Supplementary document to  
*Operating Instructions for Safety and Shut-off Block*  
(HYDAC INT 3.551.BA0)

**Only valid** for modified Safety and Shut-off Block according to  
Document: *Guideline on claim SAF32E16F*  
Doc. No.: PDI 10000773383, Rev. A

**1. Deviation in manual bleed operation for type SAF32M16...E/F**

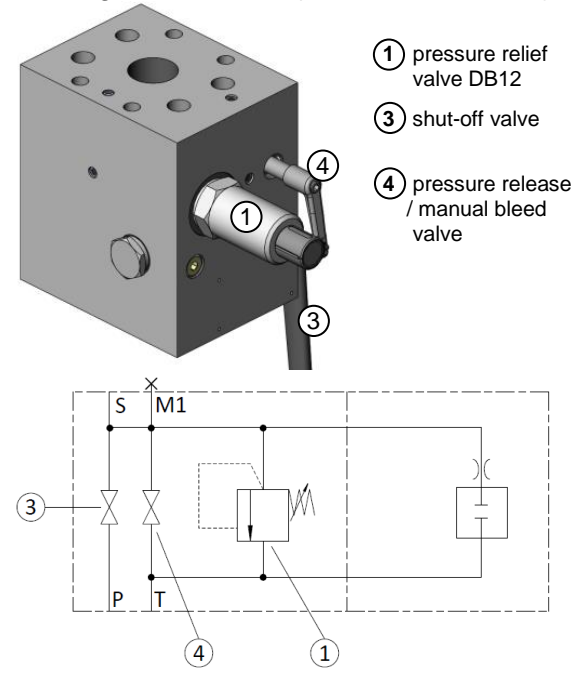
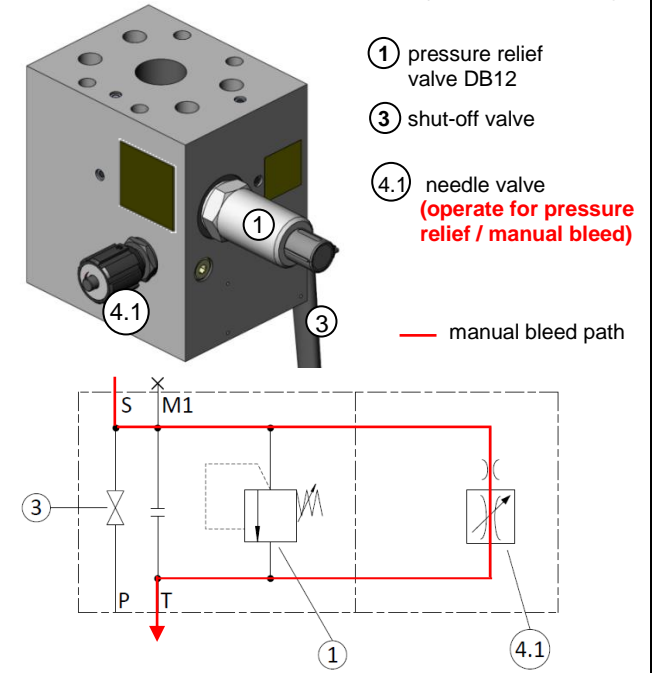
**1.1 Original condition (non-affected block)**

**1.2 Modification acc. Guideline (affected block)**

**2. Deviation in manual bleed operation for type SAF32E16Y...E/F**

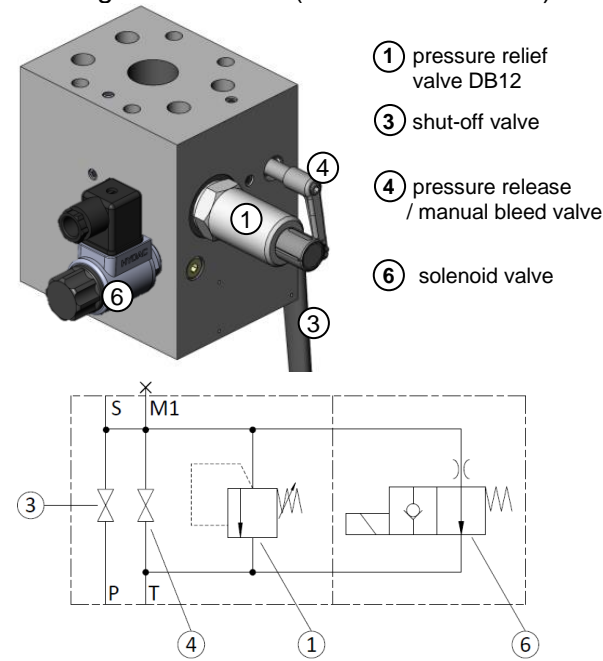
**2.1 Original condition (non-affected block)**

**2.2 Modification acc. Guideline (affected block)**
